CITY OF PORTLAND, MAINE

May 1, 2018

Project Name: 25 Monument Condominiums
Address: 25 Monument Street
Applicant: Monument Partners, LLC
Planner: Matthew Grooms

RE: Staff Review Comments for 25 Monument Street – 5-unit condominium (2017-243) –
Planning Board Review

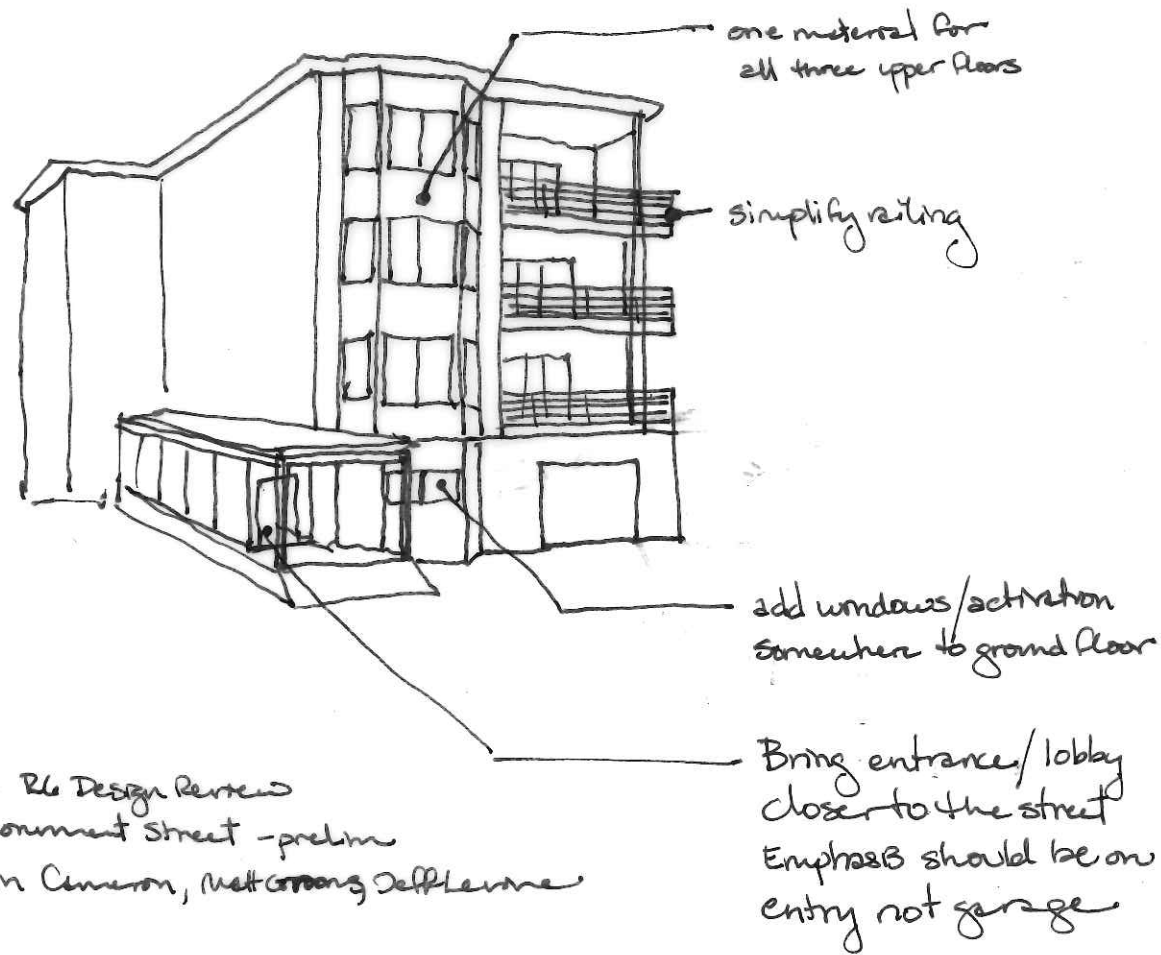
- *F-4 Delineation between Floors:* Floors are delineated with material changes and porches. The delineation between the third and fourth floors is excessive with the material change.

- *F-5 Porches, etc.:* The porches are well integrated into the massing of the building. However, the design of the railing does not meet the standard – the style is overly complex, not integrated into the overall building character or the character found in context. In addition, the design of the entry porch feels boxy and lacking detail compared with the rest of the building. The cornice profile for that porch roof is adding to the heaviness of that design.

- *F-6 Main Entries:* The main entry is set back from the street – **emphasis should be on the entry rather than the garage door.** Staff suggest bringing the enclosed entry closer to the street, aligned with the front façade and activated the ground floor by using the bay as lobby space. Porch width may need to be revised to accommodate this.
